Accessibility Review Report – DA Review

Project Title: **Northside West Stage 2
23-27 Lytton Street, Wentworthville**

Job Number: **20466**

Date: **3 November 2021**

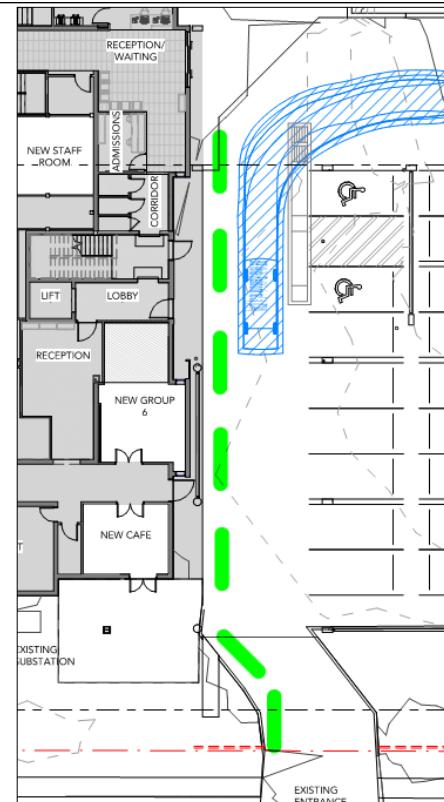
DtS Provision	Comment(s)/Recommendation(s)	Status
<p>Buildings and parts of the building must be accessible as required by Table D3.1, unless exempted by D3.4. Table D3.1 requires that access is provided –</p> <p><u>Class 5, 6 & 9a –</u> To and within all areas normally used by the occupants.</p> <p><u>Class 7a –</u> To and within any level containing accessible carparking spaces.</p>	<p>Access is generally proposed throughout the required portions of the building as prescribed by Cl. D3.1 of the BCA.</p> <p><u>Doorways</u> All doorways along an accessway are required to have a clear door opening width no less than 850mm clear and be provided with door circulation spaces as prescribed by AS1428.1-2009.</p> <p>i. <u>Compliance Departure:</u> Some doorways are not provided with a door circulation spaces as required by AS1428.1-2009. Examples of these doorways are provided below –</p> <p><u>Corridor doorways/ Doorways to terraces:</u></p>  <p><u>Doorway to patient SOU's:</u></p> 	DD

<p>i. <u>Resolution:</u></p> <p>Either –</p> <ul style="list-style-type: none"> • Provide the prescribed door circulation spaces; or • Where a compliant scenario cannot be achieved it may be possible to pursue a Performance Solution to justify some compliance departures. This is to be determined on a case-by-case basis and will require further design development/discussion. <p>ii. <u>Compliance Departure:</u></p> <p>Level 1 doorway located between Stage 1 and Stage 2 works is provided with a door setback exceeding 300mm.</p>  <p>ii. <u>Resolution:</u></p> <p>Doorway is required to have a setback no greater than 250mm to ensure there is no obstruction to the latch-side clearance to the doorway.</p> <p><u>Performance Solutions:</u></p> <p>A number of doorways/ features to doorways may be required to be addressed via a Performance Solution report, these include:</p> <ol style="list-style-type: none"> 1. Lack of door circulation space leading to individual patient SOU's. 2. Use of anti-ligature door hardware.

Figure 1 – Site Plan Mark-up

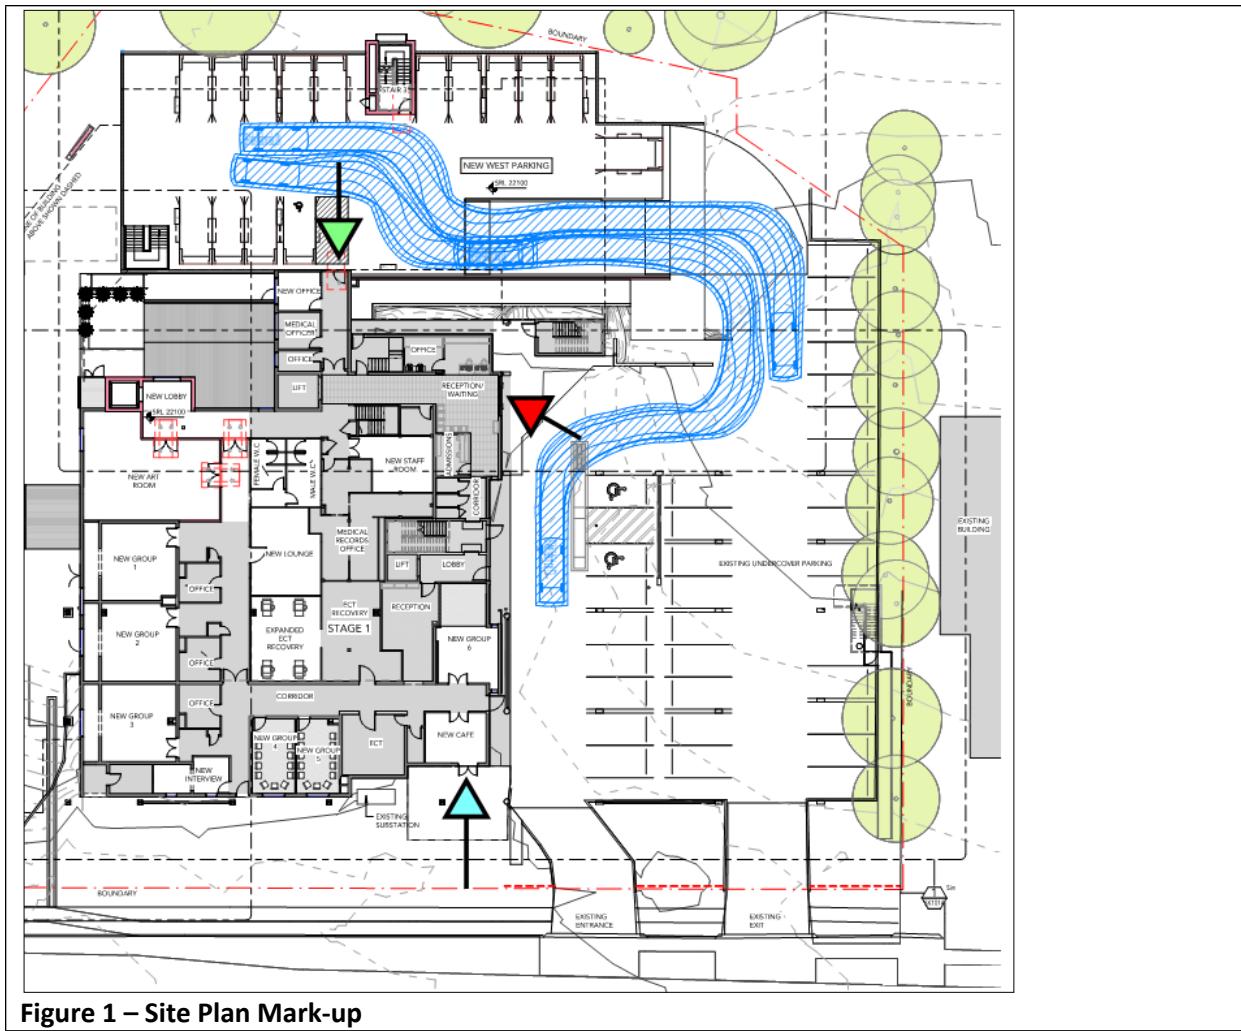
DtS Provision	Comment(s)/Recommendation(s)	Status
<p>An accessway must be provided to a building required to be accessible –</p> <ul style="list-style-type: none"> • from the main points of pedestrian entry at the allotment boundary; and • from another accessible building connected by a pedestrian link; and • from any required accessible carparking space on the allotment. <p>In a building required to be accessible, an accessway must be provided through the principal pedestrian entrance, and –</p> <ul style="list-style-type: none"> • through not less than 50% of all pedestrian entrances including the principal pedestrian entrance; and • in a building with a floor area more than 500m², a pedestrian entrance which is not accessible must not be located more than 50m from an accessible pedestrian entrance. <p>except for pedestrian entrances serving only areas exempted by D3.4.</p>	<p>The following pathways are proposed –</p> <ul style="list-style-type: none"> • 1x Principal Pedestrian Entrance (PPE) to the building from the Stage 1 area of works indicated by a Red arrow below. • 1x Principal Pedestrian Entrance (PPE) to the ‘café’ from Lytton Street indicated by a blue arrow below; and • 1x accessible entry to the building from the accessible parking space indicated by a green arrow below. <p>The existing building entry will be utilised as part of the new works to Stage 2 development works.</p> <p>At a minimum the existing door/ landing and kerb ramp will need to be assessed as part of the “affected part” assessment. See figure below:</p>  <p>Further consultation with the certifier will be required to ascertain whether the pathway between the allotment boundary and building entry will be affected.</p>	DD

Compliance is readily achievable.

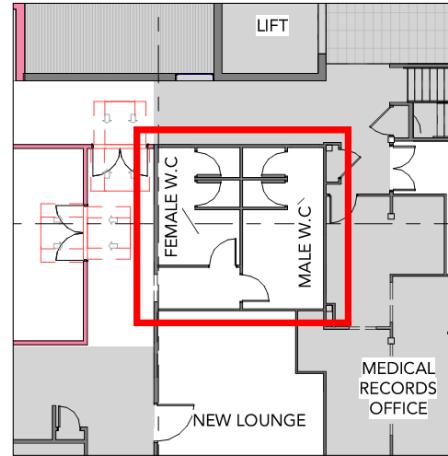
DtS Provision	Comment(s)/Recommendation(s)	Status
<p>Every passenger lift must –</p> <ul style="list-style-type: none"> • be one of the types identified in Table E3.6a, subject to the limitations on use specified in the Table; and • have accessible features in accordance with Table E3.6b; and • not rely on a constant pressure device for its operation if the lift car is fully enclosed. 	<p>1x new passenger lift is proposed.</p> <p>The proposed passenger lift shall have the following features –</p> <ul style="list-style-type: none"> • Handrail complying with the mandatory handrail provisions of AS1735.12, • Lift floor dimensions not less than 1,100mm x 1,400mm where the lift vertical travel is less than 12m, • Lift floor dimensions not less than 1,400mm x 1,600mm where the lift vertical travel is more than 12m, • Minimum clear door opening complying with AS1735.12, • Passenger protection system complying with AS1735.12, • Lift landing doors at the upper landing, • Lift car and landing control buttons complying with AS1735.12, • Lighting in accordance with AS1735.12, • Automatic audible/visual information within the lift car and at the landings as prescribed, • Emergency hands-free communication, including a button that alerts a call centre of a problem and a light to signal that the call has been received. <p>A design compliance certificate is be obtained from the lift designer to confirm compliance with the relevant provisions of the BCA and Australian Standards.</p> <p><u>Compliance Departure –</u></p> <p>A stairway platform lift is proposed in the location indicated below –</p> <p><u>Resolution –</u></p> <p>Either –</p> <ul style="list-style-type: none"> • Provide a compliant lift type; or • Where a compliant scenario cannot be achieved it may be possible to pursue a Performance Solution to justify the absence of an accessway to the subject 	<p>CoC</p>

<p>area. This is to be determined on a case-by-case basis and will require further design development/discussion.</p> <p><u>Design Detail –</u></p> <ul style="list-style-type: none"> • Ensure lift landing controls are provided no less than 500mm from an internal corner. 	
--	---	--

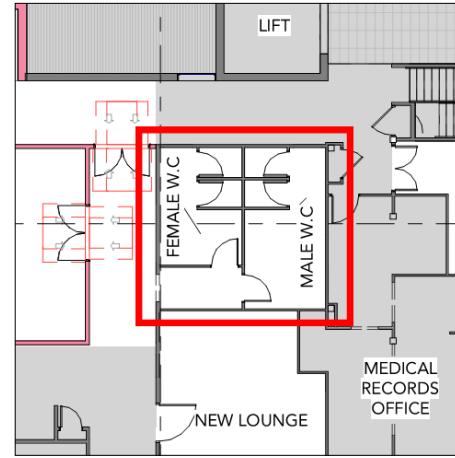
DtS Provision	Comment(s)/Recommendation(s)	Status
<p>In a building required to be accessible:</p> <ul style="list-style-type: none"> • Accessible unisex sanitary compartments must be provided as in accordance with Table F2.4(a), • Accessible unisex showers must be provided in accordance with Table F2.4(b), • At each bank of toilets where there is one or more toilets in addition to an accessible unisex sanitary compartment at that bank of toilets, a sanitary compartment suitable for a person with an ambulant disability in accordance with AS 1428.1 must be provided for use by males and females. • An accessible unisex sanitary compartment must contain a closet pan, washbasin, shelf or bench top and adequate disposal of sanitary towels. • Circulation spaces, fixtures and fittings of all accessible sanitary facilities must comply with AS1428.1. • An accessible unisex sanitary facility must be located so that it can be entered without crossing an area reserved for one sex only; and • Where two or more of each type of accessible unisex sanitary facility are provided, the number of left and right handed mirror image facilities must be provided as evenly as possible. 	<p><u>Accessible sanitary compartments –</u></p> <p>2x accessible sanitary compartments are proposed to be located on Levels 1, 2 and 3 (total of 6) and have compartment sizes capable of complying with AS1428.1-2009.</p> <p>i. <u>Compliance Departure:</u> Left and right hand closet pan transfers are not provided as evenly as possible –</p> <ul style="list-style-type: none"> • 6x LH • 0x RH <p>i. <u>Resolution:</u> Ensure LH and RH transfer accessible sanitary compartments are provided as evenly as possible.</p> <p>ii. <u>Compliance Departure:</u> An accessible sanitary compartment is not provided in the area indicated below on the Ground floor where works to the male and female bathrooms are proposed –</p>	DD

i. Compliance Departure:

Drawings are to indicate allocation of ambulant cubicle within Ground Floor toilet bank.

ii. Resolution:

Provide an accessible sanitary compartment as prescribed.

i. Resolution:

Provide allocation of ambulant cubicles within the Ground Floor bank of toilets.
